ADDENDUM # 2

Date: 08/13/2026

IFB #3050 **Historic Courthouse HVAC Upgrades**

DRAWING NO.
A103
Drawn By: LMG Checked By: MTP

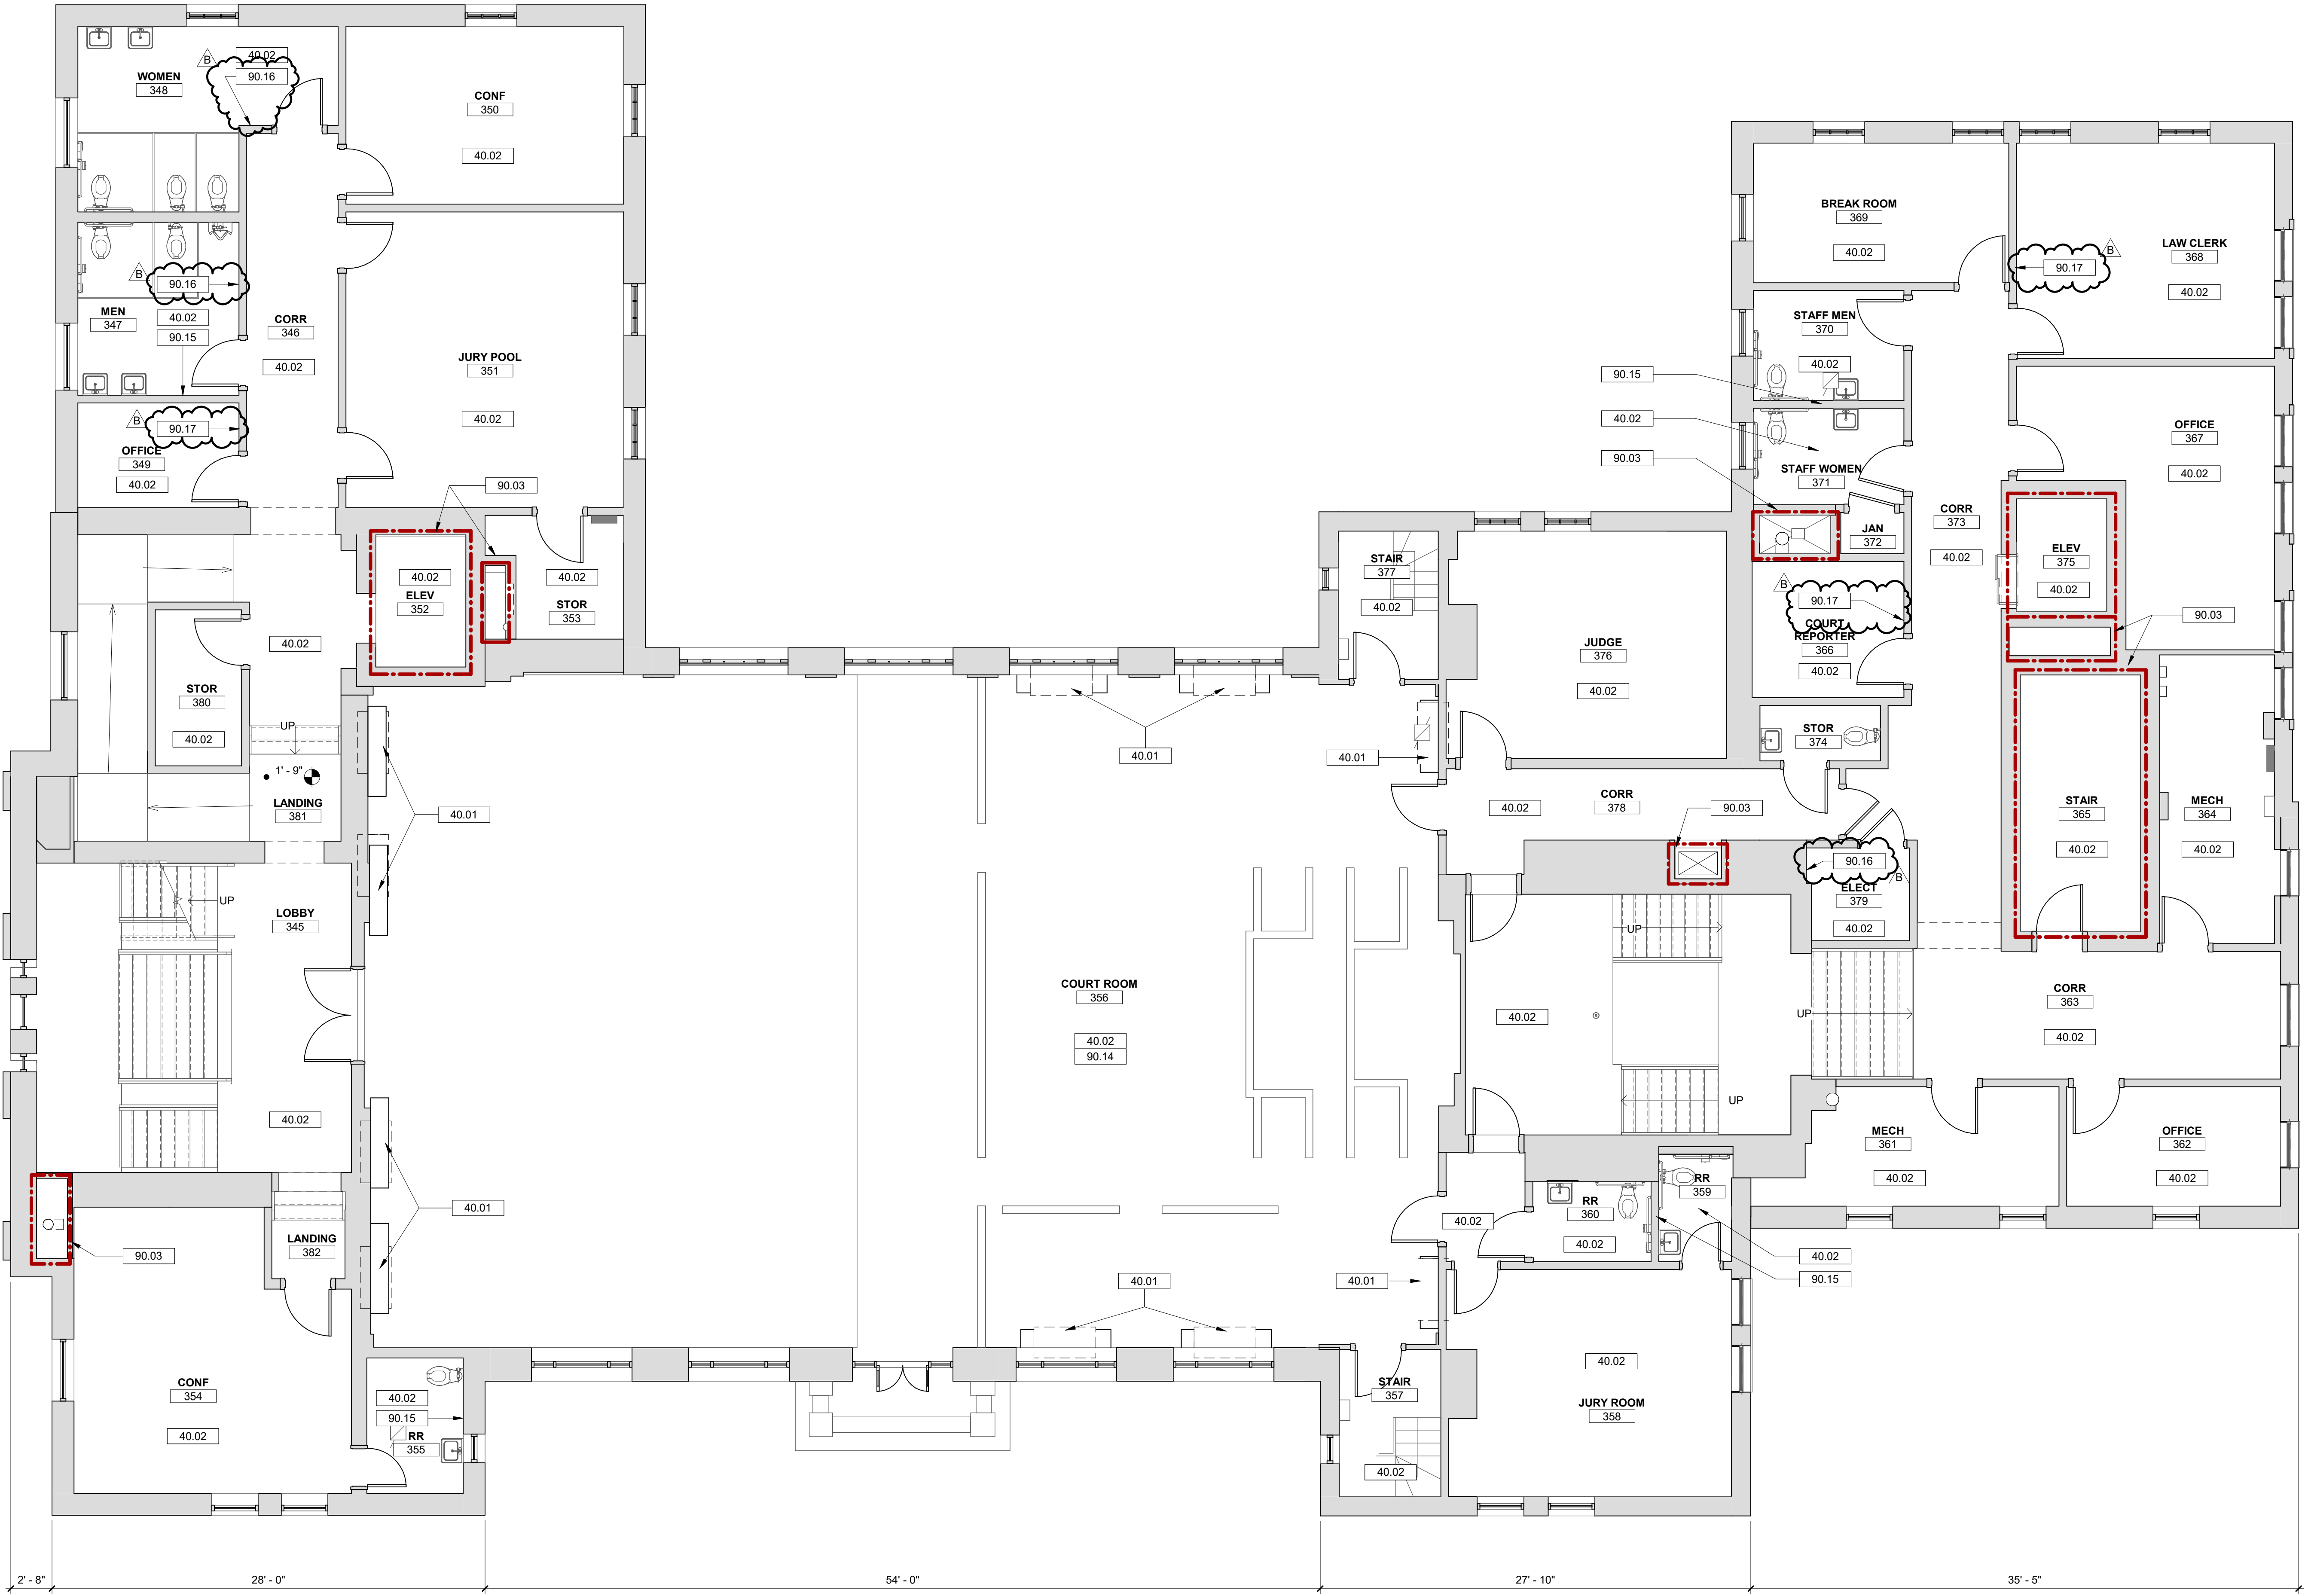
- Drawing Note 90.01 is revised to read, "ALL EXISTING SUSPENDED ACOUSTIC CEILING SYSTEMS TO BE REMOVED AND REPLACED WITH NEW FOLLOWING INSTALLATION OF NEW MECHANICAL AND ELECTRICAL WORK. ALL EXISTING CEILING GRID TO BE DEMOLISHED. ALL HVAC UNITS, DIFFUSERS, AND RETURNS TO BE REMOVED AND REPLACED WITH NEW; REFER TO MECHANICAL DRAWINGS. ALL LIGHTS AND OTHER CEILING-MOUNTED DEVICES TO REMAIN UNLESS NOTED OTHERWISE; REFER TO ELECTRICAL DRAWINGS. LIGHTS AND OTHER MISCELLANEOUS DEVICES TO BE TEMPORARILY HUNG FROM THE STRUCTURE ABOVE AND PROTECTED DURING DEMOLITION. ALL EXIT SIGNS, SMOKE AND FIRE DETECTORS, AND SPRINKLERS TO REMAIN AND BE PROTECTED DURING DEMOLITION. WHERE EXISTING BATT INSULATION IS ENCOUNTERED ABOVE ACT SCHEDULED FOR DEMOLITION, REMOVE AND NOTIFY OWNER AND ARCHITECT. DO NOT INCLUDE REPLACEMENT IN BASE CONTRACT. DO NOT REMOVE BATT INSULATION ABOVE GYPSUM BOARD OR PLASTER CEILINGS."

- Drawing Note 90.02 is revised to read, "DRYWALL AND PLASTER CEILINGS AND SOFFITS TO REMAIN. LIGHTS TO REMAIN UNLESS NOTED OTHERWISE. ALL PLASTER CEILINGS AND WALLS ARE CONSIDERED HISTORIC; PROTECT DURING DEMOLITION. WHERE EXISTING BATT INSULATION IS ENCOUNTERED ABOVE DRYWALL OR PLASTER CEILINGS, LEAVE IN PLACE AND UNDISTURBED."

3 UNDERGROUND THRUST BLOCK DETAILS
M050 NOT TO SCALE

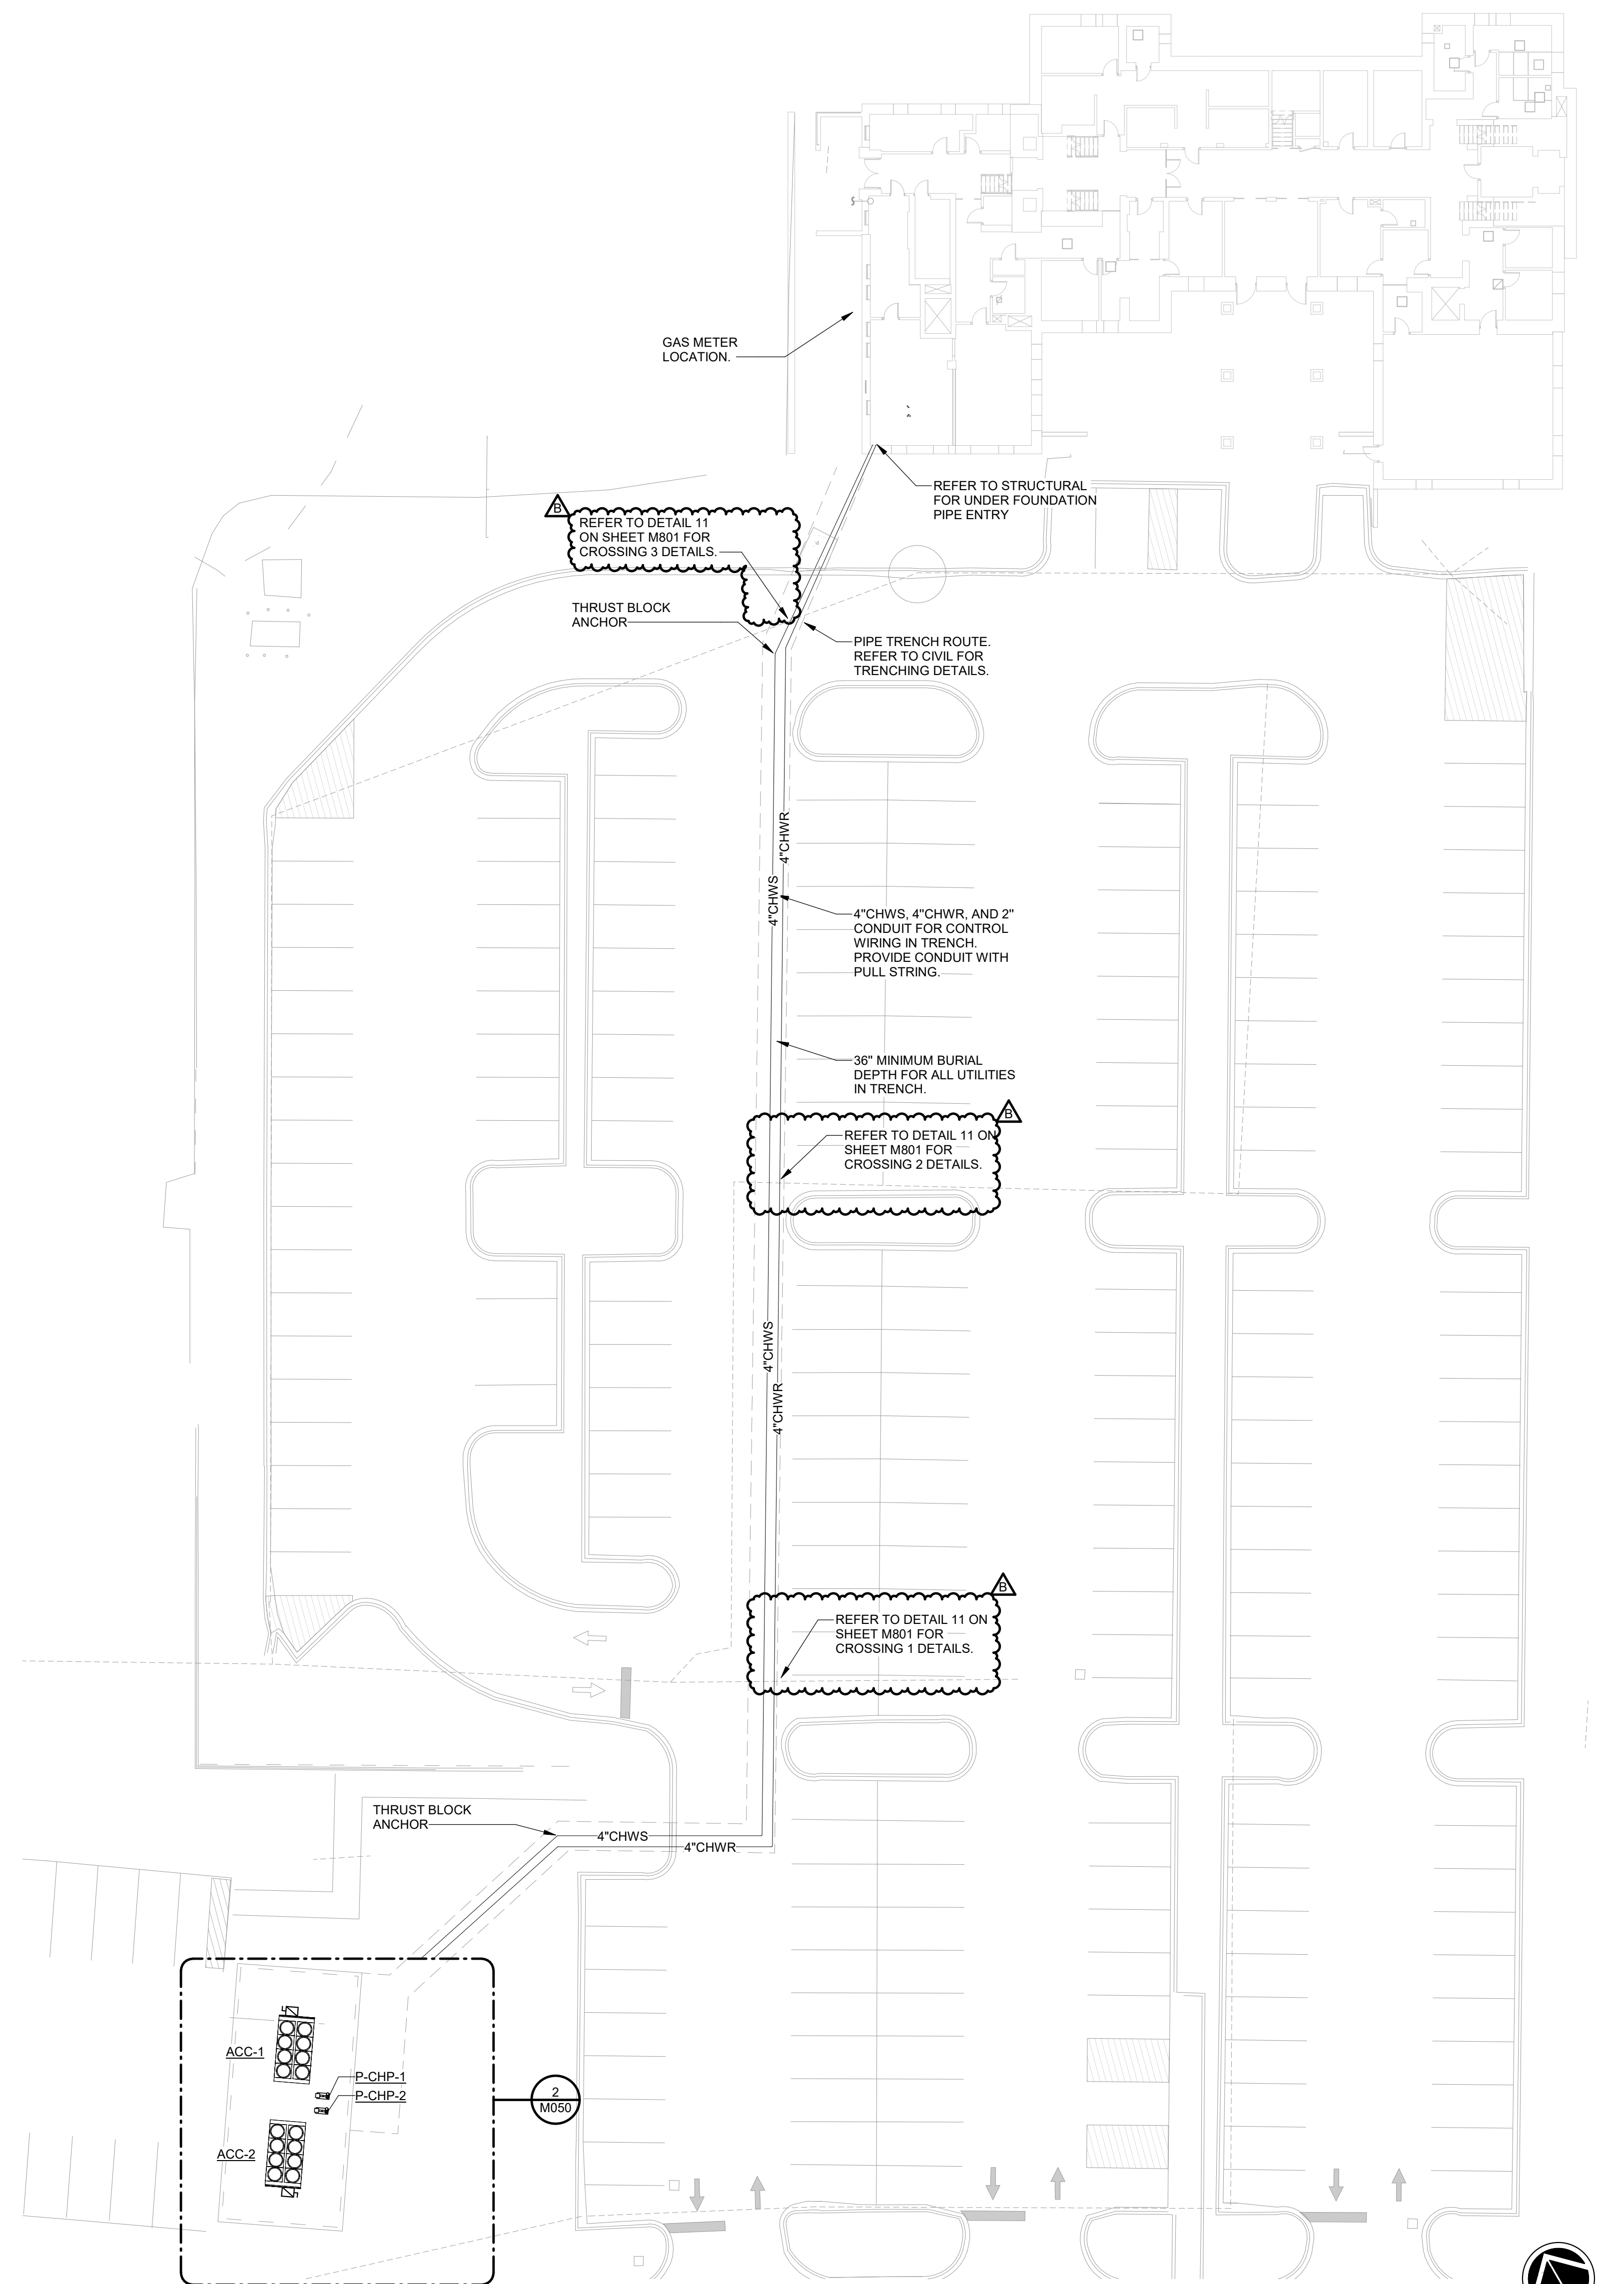
14. M050 note says "see structural for under foundation pipe entry" this is not on the structural plans. please provide detail.
Response: See Detail 1/S201. This is an existing structure, and the pipe entry will need to avoid the existing foundation. If it is above the foundation, the wall will need to be cored. If it is below the foundation, it will need to be sleeved and grouted similar to the detail.
